B2065
4/5/18
FAO Steven Warren, LLFA

Clitheroe Light Engineering- new building proposals- 3/2017/1020

APPLICATION CONSULTATION RESPONSE

Application Number:	3/2017/1020
Location:	Unit A to C Up Brooks, Clitheroe, BB7 9SE 1 PL
Grid Ref:	E 375182, N 442128
Proposal:	Proposed new production unit

PIT 2 LOCATION

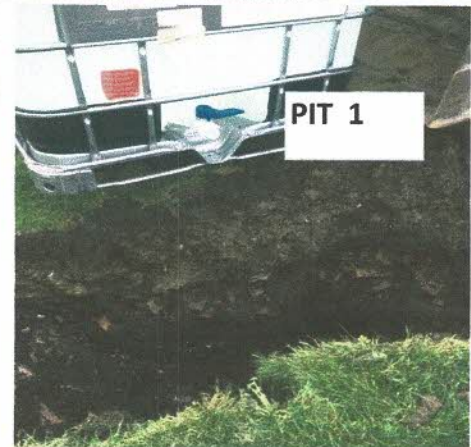
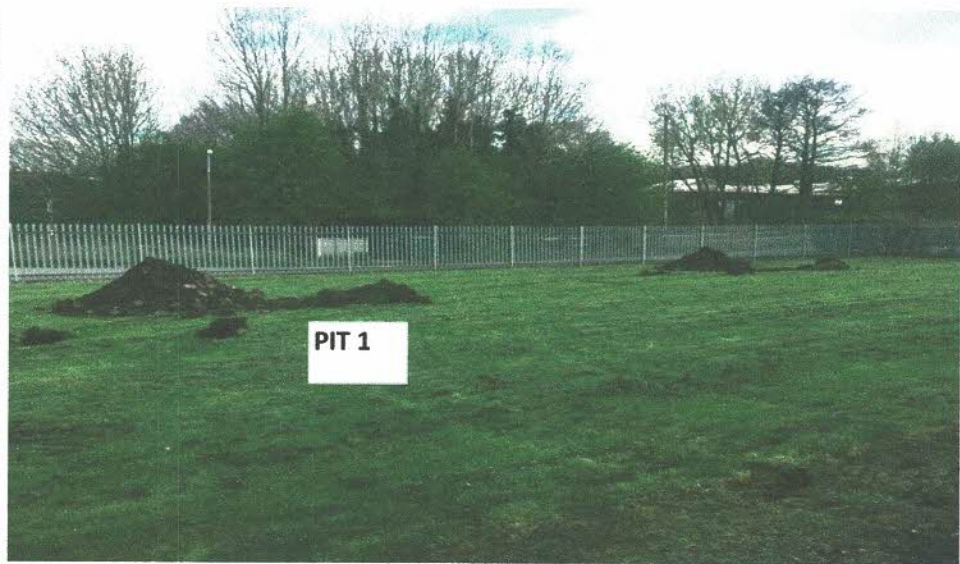
- Proposed site plan showing exceedance routes and building slab level

Site investigation report, including the results for each SuDS feature of :

The drainage hierarchy (1) of soakaway, watercourse, drainage system has been followed and the percolation test results (2) show ground with limited soakage. New surface water runoff will connect to United Utilities public surface water manhole 1105 and an exceedance diagram is attached (3) showing runoff routes over the roads into Mearley Brook. In terms of sustainable drainage calculations the BRE 365 procedure spreadsheet shows that a 20m length soakaway 0.8m sidewall depth can cope with 2.76m³ of runoff in 24 hours. A site for a soakaway is to the west of the new building and as soakage is limited the cellular crate surface water storage of 25m³ will be placed here to at least soak some runoff into the ground as well as provide storage. Flow calculations are new hard area 1000m² x 0.014 l/sec/m² for a 1 in 2 year storm (Building Regs Approved document H) giving 14 l/sec, a 1 in 30 year runoff rate is 14 x 1.9 growth factor = 27 l/sec, 1 in 100 year runoff rate 14 x 2.5 GF = 35 l/sec, 1 in 100 year + 30% CC = 45.5 l/sec. (4). The HR Wallingford printout shows the storage volume. Post consent, detailed Microdrainage calculations and contract drawings showing drainage, slab levels, and road levels will be prepared for Building Regulations submission.

Dug out to 1.600mm deep .

1500l of water was poured into the hole at 11.19am.

The hole never filled more than 800mm high whilst the water was being poured into the hole
